Airstream Interstate NHTSA 19V-906/Transport Canada 2020-006 Occupant and Cargo Carrying Capacity (OCCC) Label Replacement Instructions

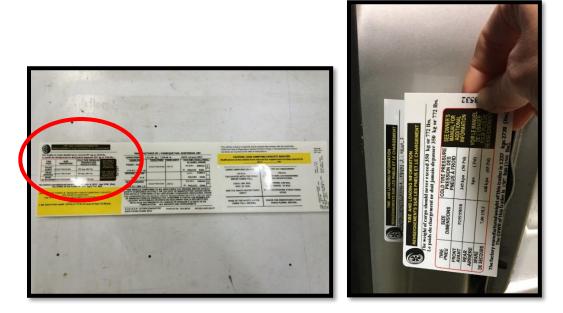
<u>Step 1</u>: Locate the labels that need to be replaced. Replace both the yellow Motor Home Occupant Cargo Carry Capacity Label on the Passenger Side Door and the white Cargo Carrying Capacity Label on the Driver's Side B-Pillar.

<u>Step 3</u>: Remove the corrected "Tire and Loading Infomormation" label and place it over the existing label on the on the Driver's Side B-Pillar.

<u>Step 4</u>: Remove the corrected "Motor Home Occupant Cargo Carrying Capacity" label and place it over the existing label on the Passenger Side Door.
